**MAJOR PROJECT APPROVAL NO. MP10\_0110 MOD 3**  
**Concept Plan Modifications – Response to Submissions**

# Achieve Australia

## Concept Plan Modifications – Response to Submissions

Submission from City of Ryde Council

**Figure 2**

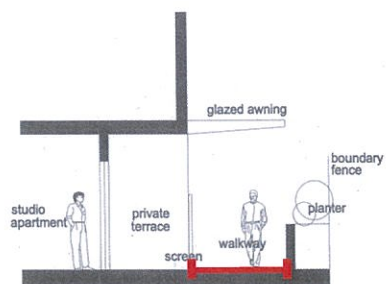
2. Removal of separation to Block E will unduly reduce the amenity within this area through:
  - a. **Excessive Visual Bulk and Massing presented to the residential buildings and through site link on 2-4 Porter St.** The removal of the separation between Block A and E removes the break in the building massing and results in an unbroken continuous built form of approximately 84m. This is exacerbated by the lowered nature of the through site link as shown in **Figure 2**.

The deletion of the through site link on the subject site is supported due to the location of the through site link on 2-4 Porter St, Meadowbank which is under construction at this time. However, concerns are raised regarding the proposed accessible footpath between buildings A and E. In this respect, Council does not own the through site link but only has a right-of-way over the adjoining property. This right-of-way does not extend to the shared boundary between the two developments but covers only the limited walkway area, shown in red on **Figure 2**.
